ADDENDUM NO. 2

Whiteland Community High School Phase 2A
300 E. Main Street
Whiteland, IN 46184

PROJECT: Whiteland Community High School Phase 2a

DATE OF ADDENDUM: May 2, 2024

DIRECTORY PATH : R:\Active\unice+beade\Whiteland High School\Design\CAD\Plans\Phase 2
DATE: 04/02/2024
USER : S12.2024.11592.AN.J.AB60

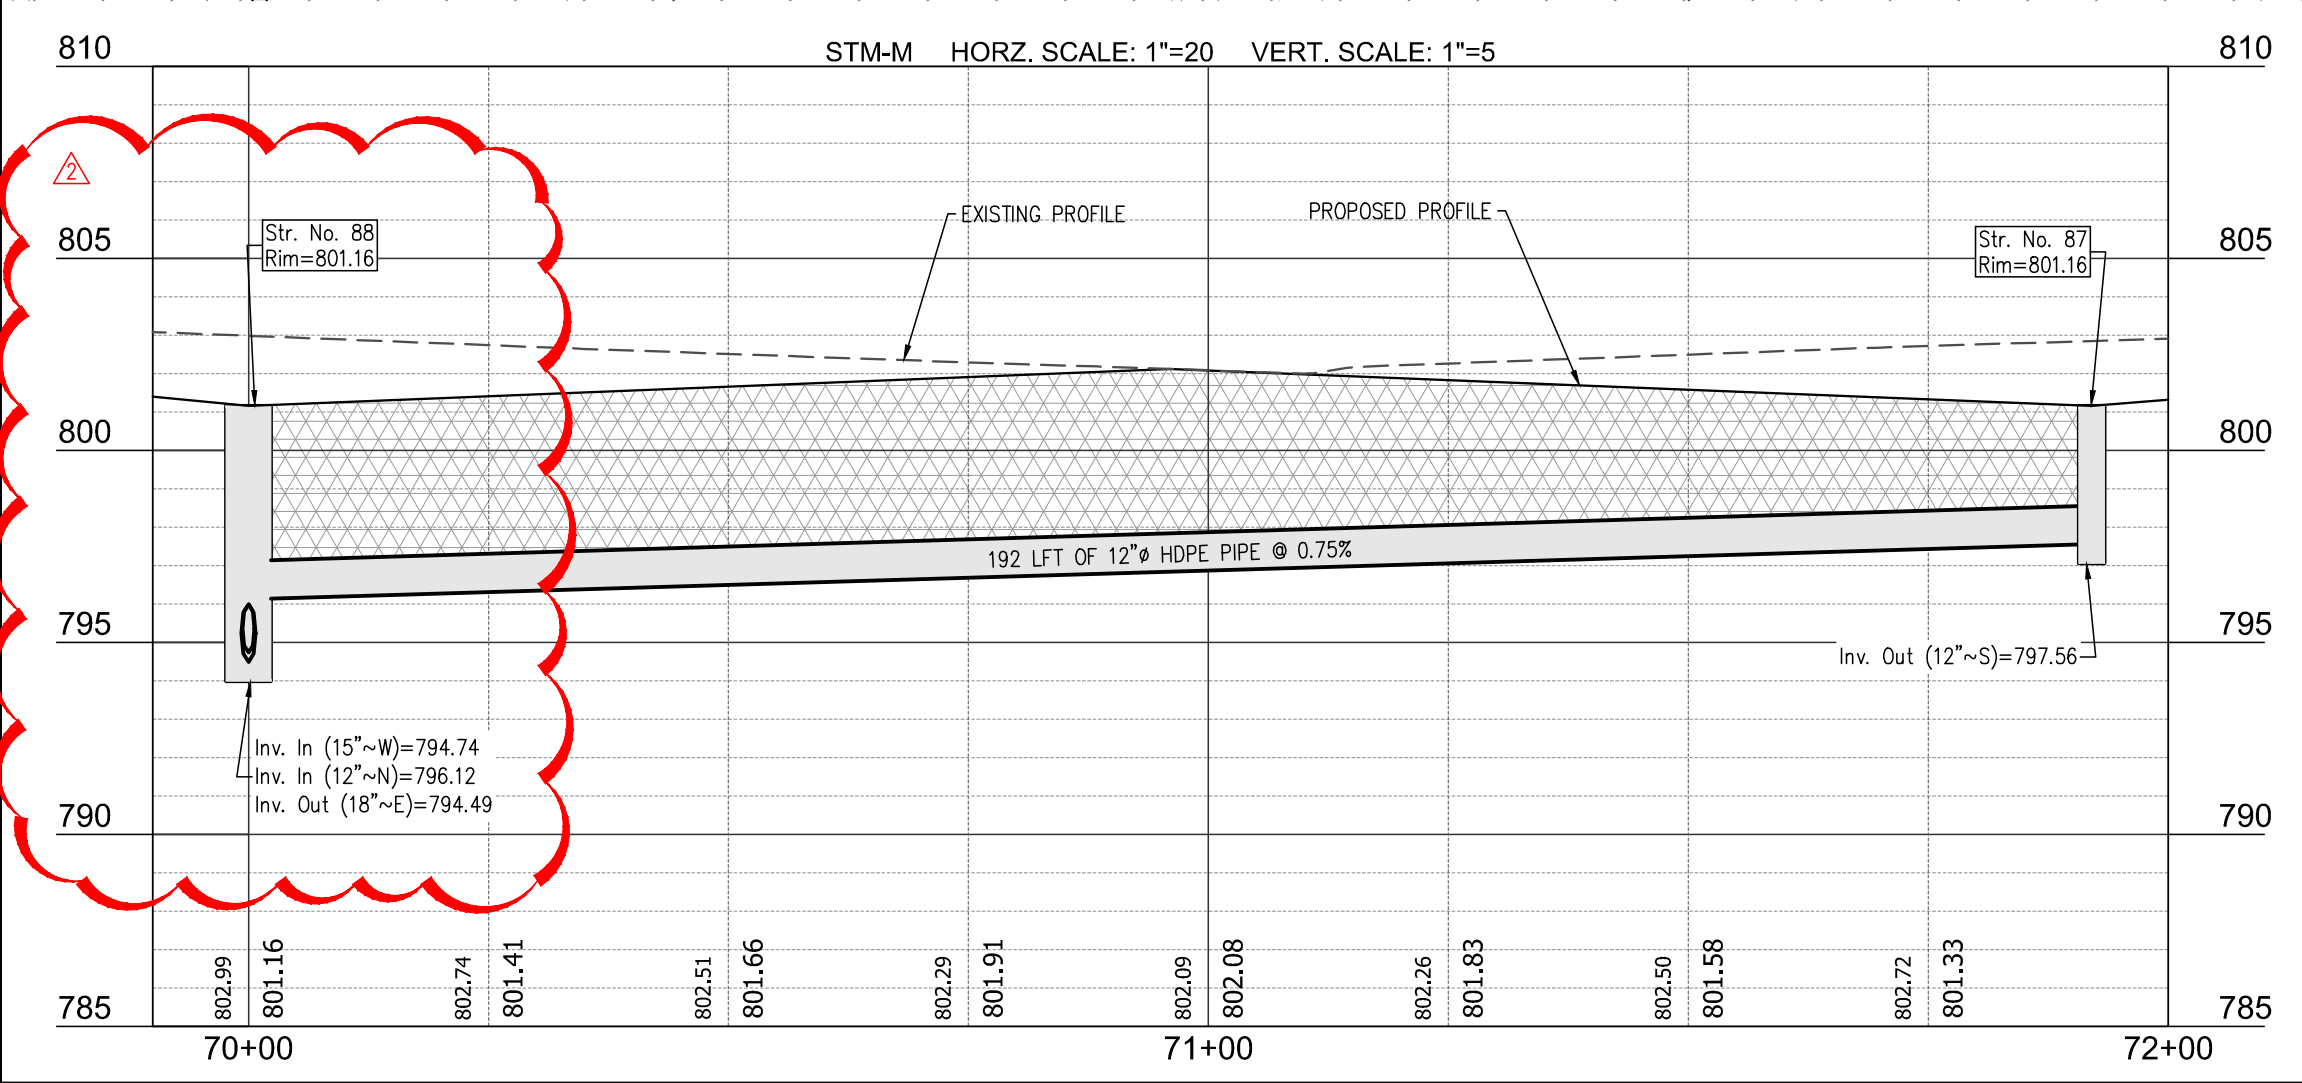
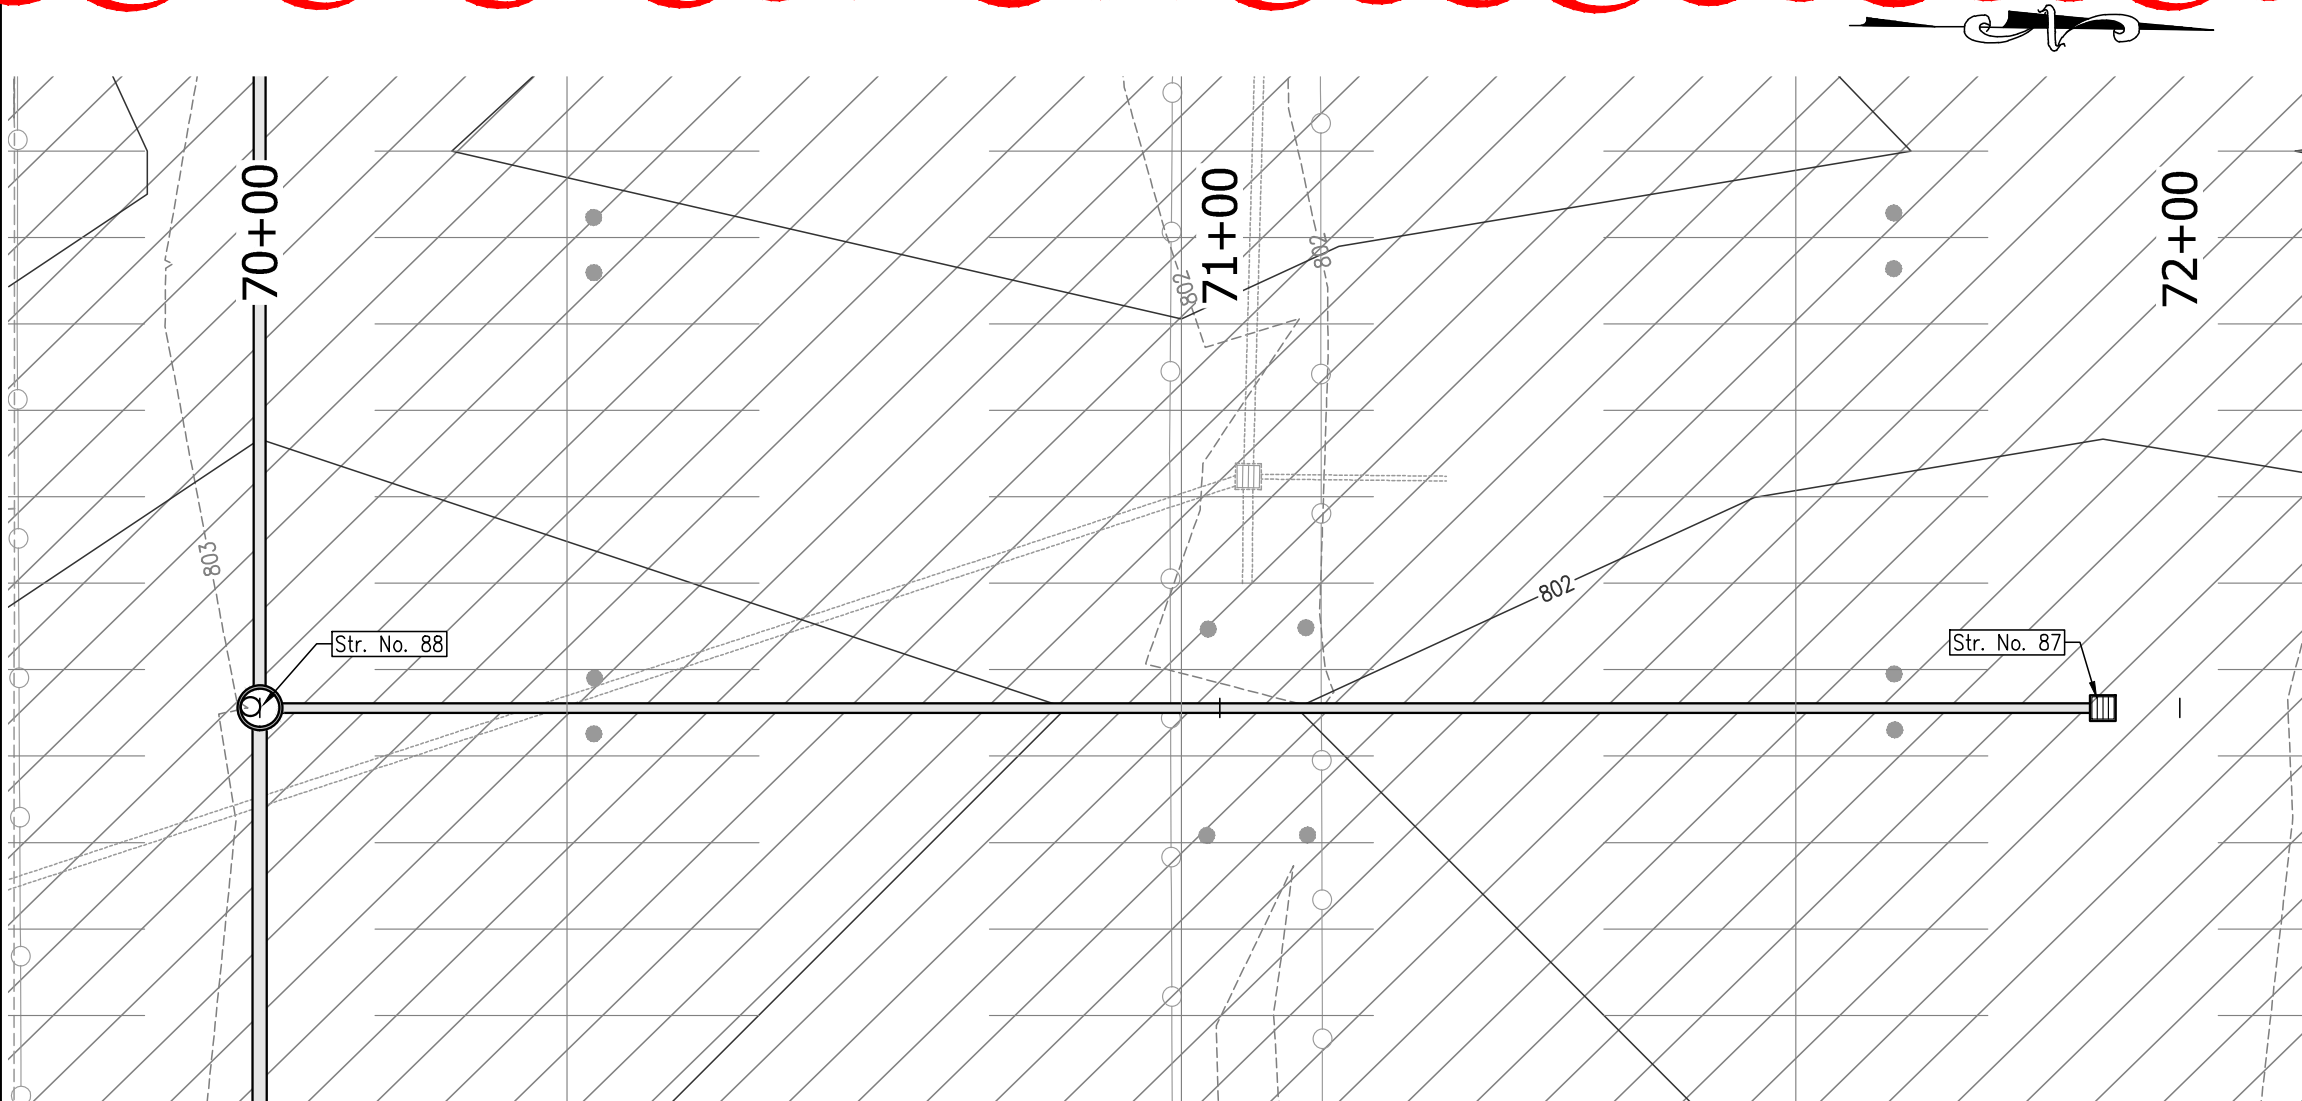
- 14 Storm Plan and Profile (sheet 801):**
 - o Str. No. 85 – reduced pipe size to 12” HDPE and revised invert elevation as shown.
 - o Str. No. 86 – revised invert elevations as shown.

JOB NO.	DRAWN	CHECKED	DESIGNED	DATE	APPR.	SHEET
				APRIL 02, 2024		803

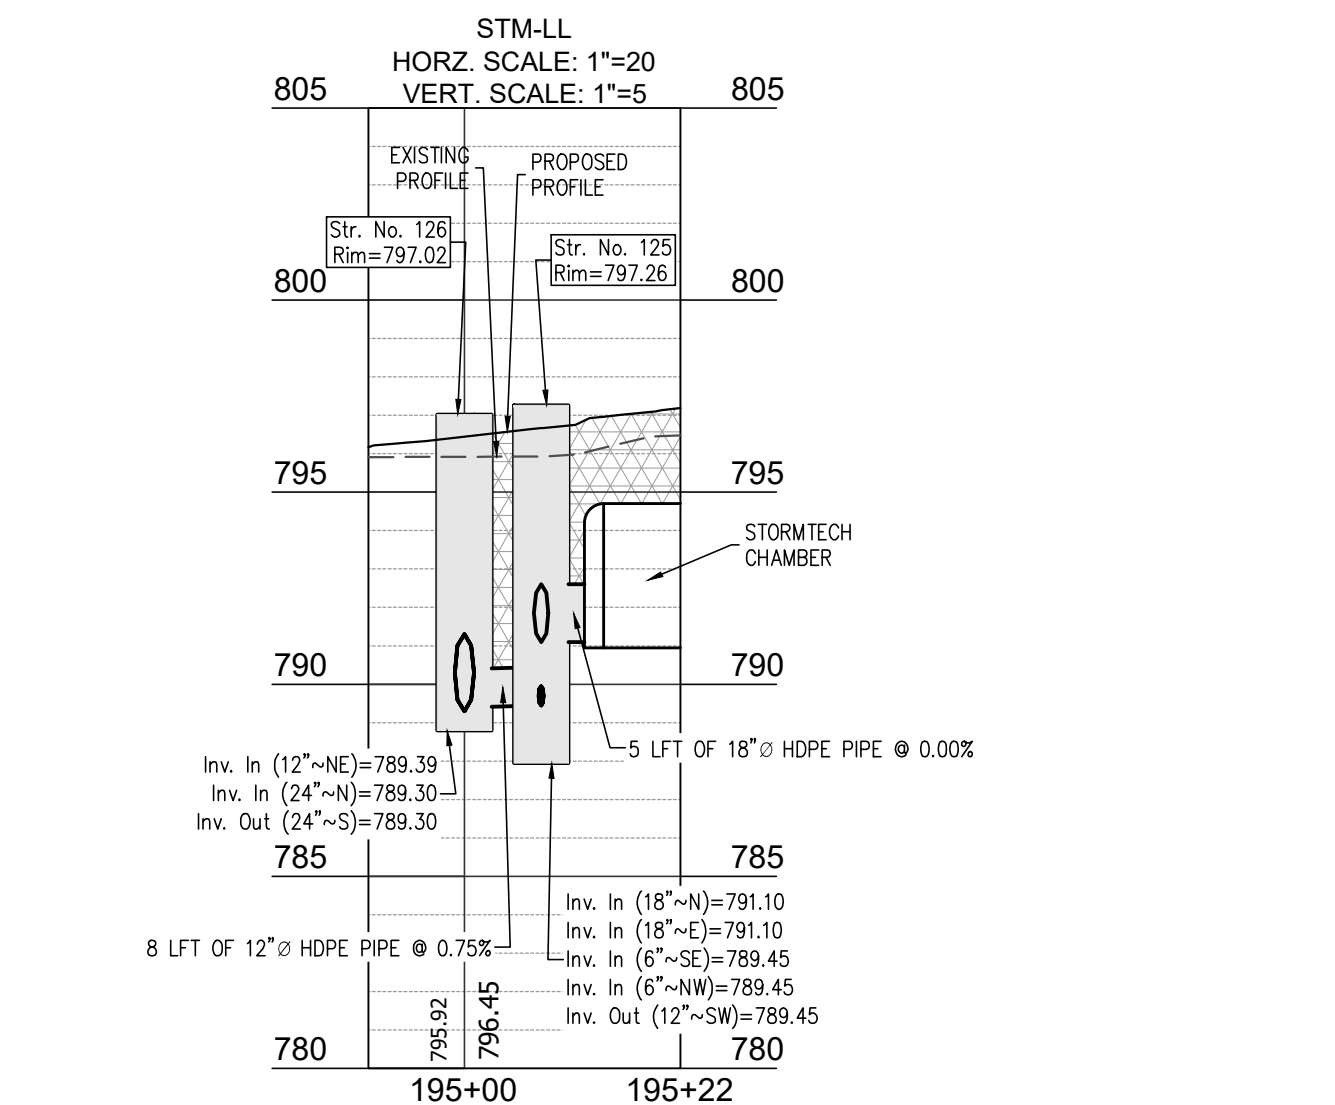
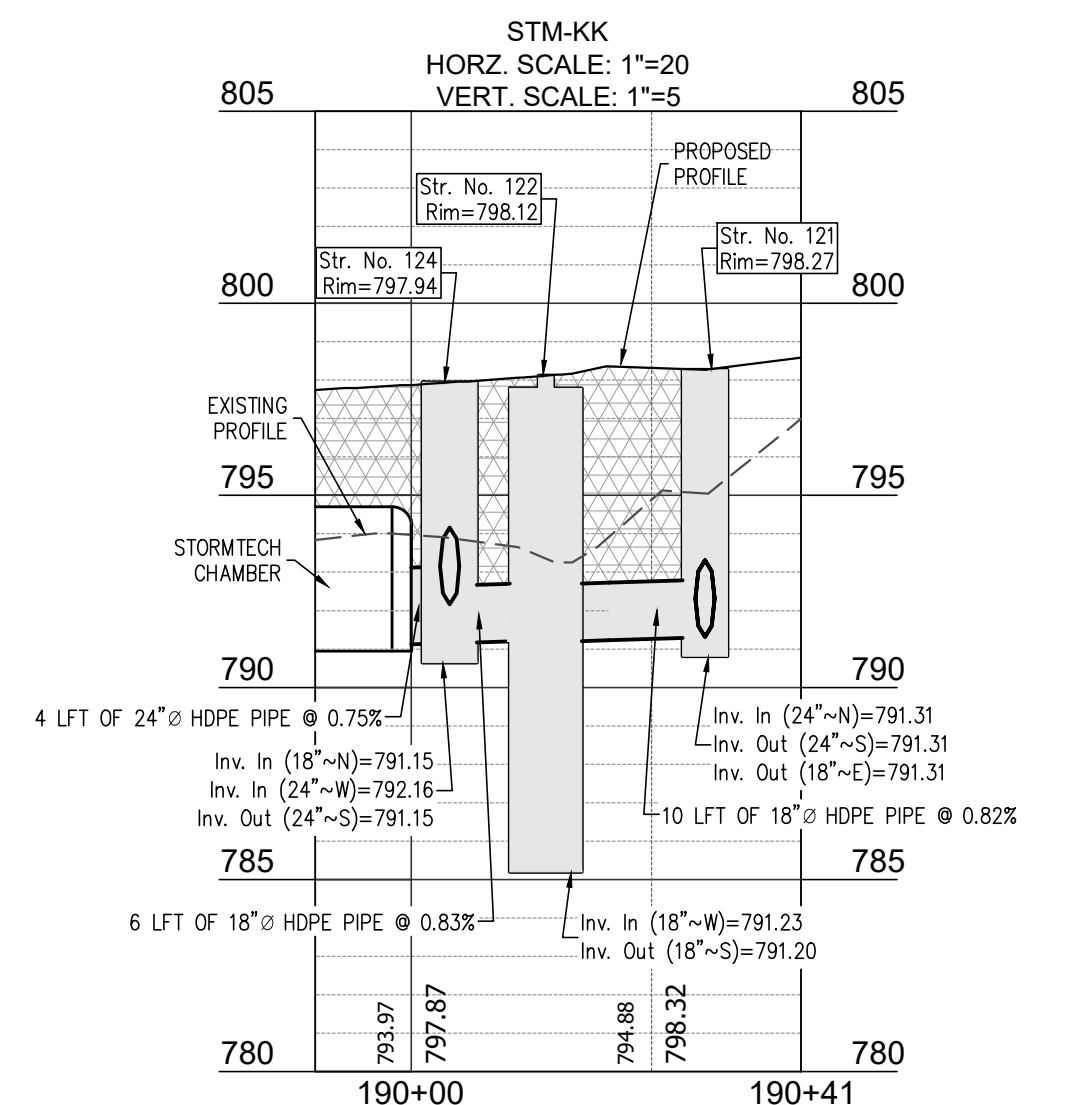
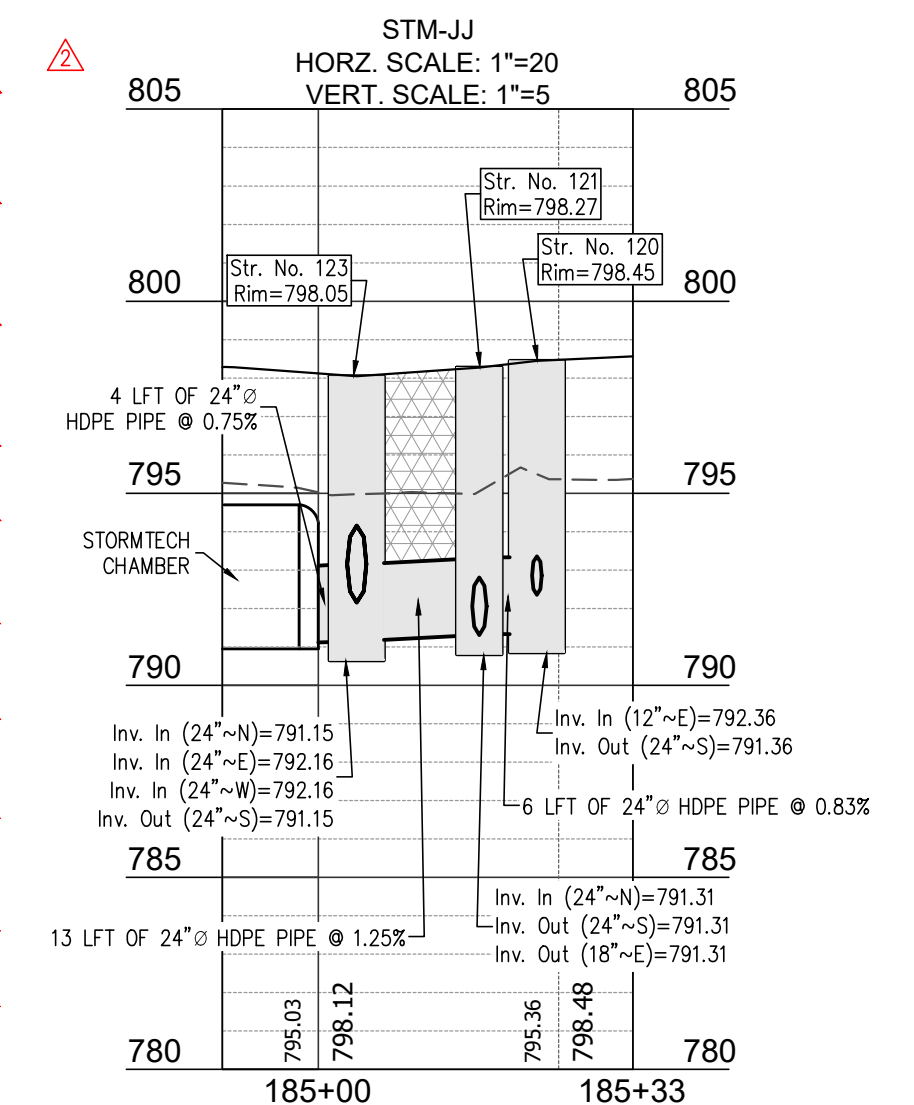
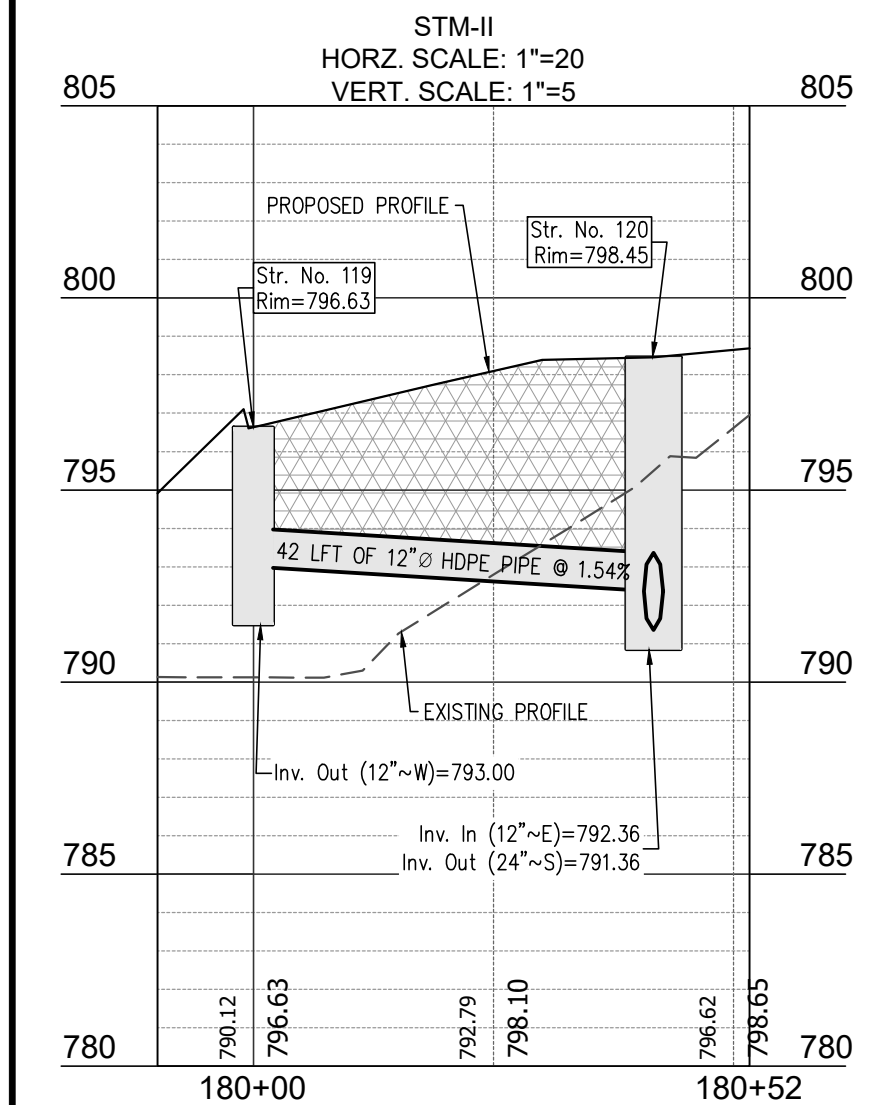
- 16 Storm Plan and Profile (sheet 803):**
 - o Str. No. 97 – increased pipe size to 15” HDPE and revised invert elevations as shown.
 - o Str. No. 98 – revised invert elevations and pipe slopes as shown.
